## WING WALL MODIFICATION

Bulletin Type:	SRP
Bulletin #(s):	22-062
Job Code(s):	If affected unit has warranty remaining, submit your claim following the normal process
Flat Rate(s):

Publication Date:	May 2022
Make(s):	Jayco & Entegra Coach
Model(s):	Seneca, Seneca, Prestige, Accolade, Accolade XL
Model Year(s):	2022 & Prior

Incident:	Excess flexing, squeaking, or cracking at transition between cab and house.
Affected Units:	Certain 2022 & Prior Jayco Seneca & Seneca Prestige; Entegra Coach Accolade & Accolade XL
Parts List:	N/A
Misc. Tools & Supplies:	2 - Wing Wall Plywood (Contact Jayco Parts to order) 2 - 10 OZ Quad Glue (Purchase Locally) 45 - #10 by 1", 3/8 hex head self-tappers (Purchase Locally) 8 - #10 by 1", 3/8 hex head, self-tapping screws (Purchase Locally)
Parts Return Information:	N/A

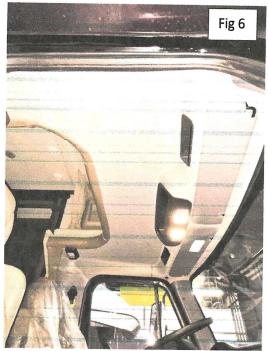
- 4) Remove the horseshoe fabric trim that connects the bed to the driver side ceiling. (Figure 3)
- 5) Place bunk mattress in safe place. Then remove staples and screws from foam bumper tube to access bunk wood panel. (Figure 4)
- 6) Proceed by removing the wing interior backer from under the stapled fabric. (Figure 5)

Fig 11

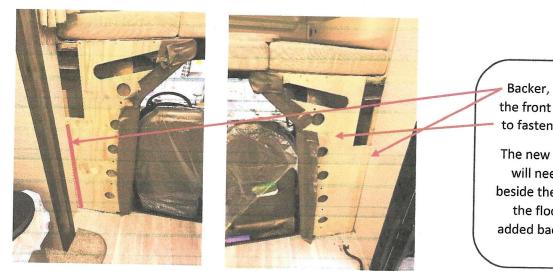
11) Using a right angle screw gun attachment, glue and screw 1"x4" backer to wall end where new wing wall plywood will be installed. Add the new plywood wing wall by fastening it to the cleats, bunk, and radius side, screw to fiberglass and B pillar. (Figure 11)

Backer, 1"X4", is added to the front end of the sidewall to fasten interior wing wall.

The new wing wall plywood will need to be cut to fit beside the wall and on top of the floor in front of the added backer to be secured.

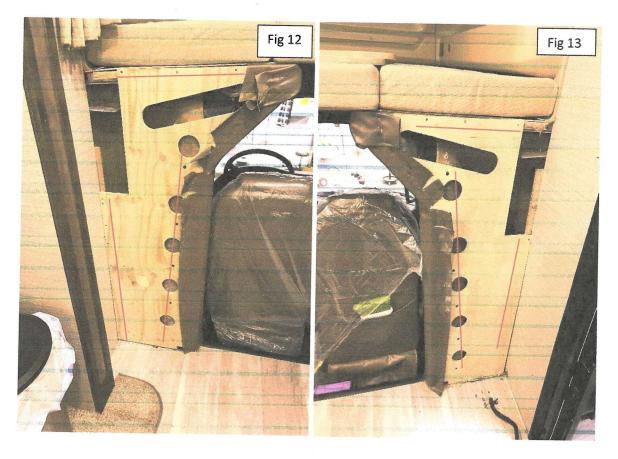
12) Add glue and screws to the perimeter of the wing wall plywood into 1"x4" backer added to the end of the wall. (Figure 12 & 13)
